P-4736
S1159
27043

SYMBOL OF QUALITY AN ISO 9002 COMPANY	<b>JINDAL ALUMINIUM LTD.</b> BANGALORE-560073 (INDIA)	NAME		DATE
		DRAWN	RAGHAVENDRA	17-09-2004
1. ALL DIMENSIONS ARE IN mm. 2. ROUND OFF ALL SHARP CORNERS WITH 0.40 mm. 3. TOLERANCES WILL BE AS PER IS:6477-1983 UNLESS OTHERWISE SPECIFIED		CHECKED		
		APPROVED		
PARTY'S NAME HYDINT LLOYDS CONTROLS,, AHMEDABAD		SCALE		1:1
		AREA mm <sup>2</sup>		3317.1
PARTY'S DRAWING No. ACT-5512-01-E R1		PERIMETER mm.		335.042
		WEIGHT kg/m		8.956
ALLOY & TEMPER 6063 T6		DRAWING No.		P-4736
		SECTION No.		-
DESCRIPTION ACTUATOR BODY		S1159		S1159-ISSUE-2
		27043		27043

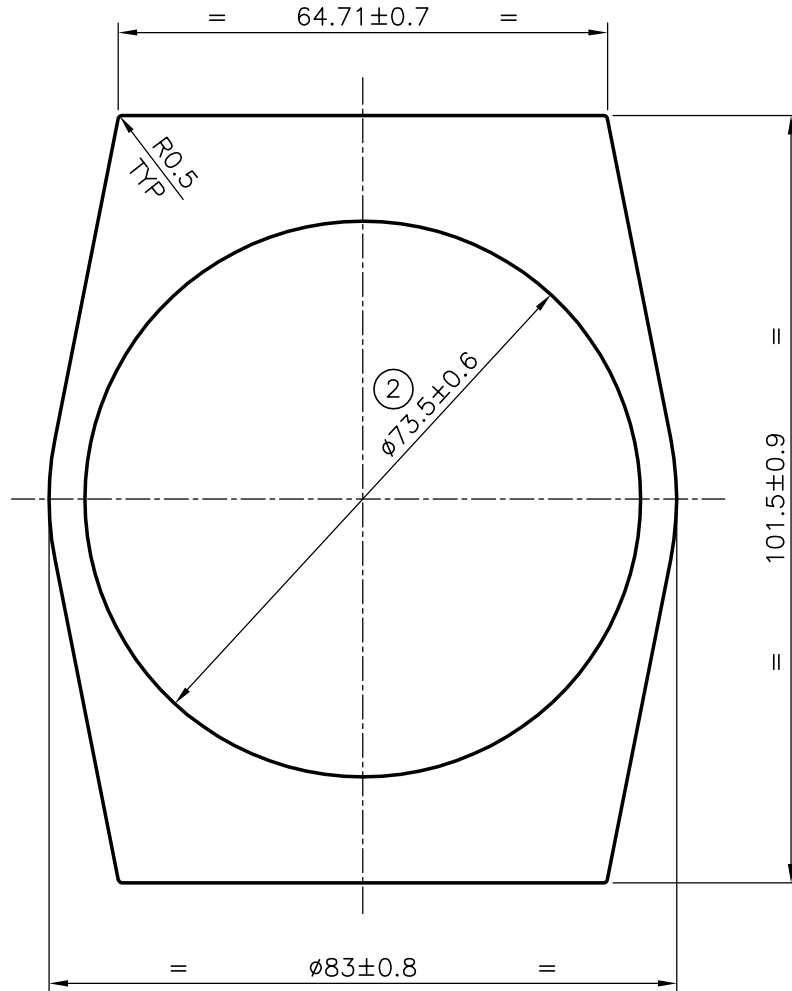
ISSUE-2 DIMENSION CHANGED FROM  $\phi 74.50 \pm 0.060$  TO  $\phi 73.50 \pm 0.60$   
 OVALITY TOLERANCE CHANGED FROM  $\pm 1.30$  TO  $\pm 1.00$   
 AND WEIGHT ALSO CHANGED FROM 8.642 TO 8.956 kg/m
